PETTWAY PLACE SUBDIVISION

APPLICATION NUMBER 13 DATE September 18, 2008

REQUEST Subdivision

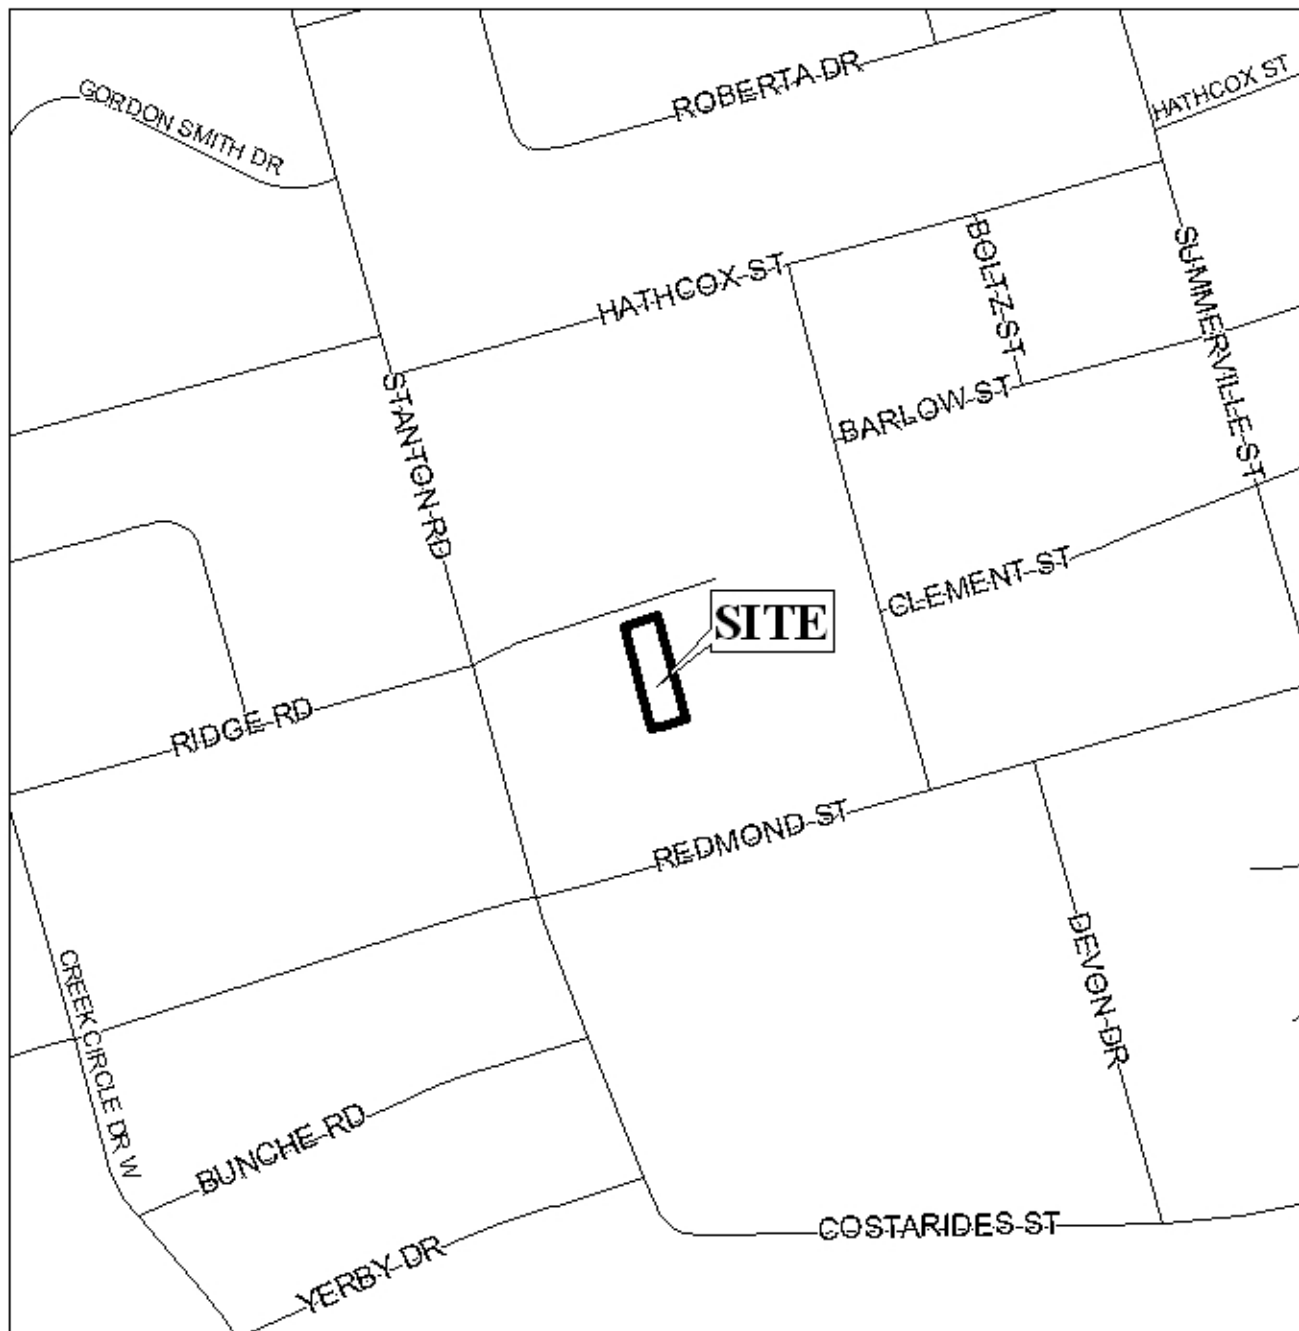
The plat illustrates the proposed 1-lot, 0.2± acre subdivision which is located on the South side of Ridge Road, 206'± East of Stanton Road, in Council District 1. The subdivision is served by public water and sanitary services.

As submitted, the plat does not agree with the parcel and lot configuration of the City G.I.S. database, or the City Engineering mapping system. The subject site appears to contain a portion of a metes-and-bounds parcel to the West shown on the mapping systems, and also appears to encroach into the adjacent residence and property to the East, as indicated on the mapping systems. Given, there may be mapping system errors, but until resolution of the discrepancies is achieved, an accurate review of this case cannot be done.

Based on the preceding, this application is recommended for holdover until the October 16th meeting, with requested information due by October 3rd, to allow the applicant to submit the following:

- 1) documentation and/or field survey verification to establish the accuracy of the plat and resolve discrepancies between the plat and mapping systems (including verification of encroachments onto adjacent residence).
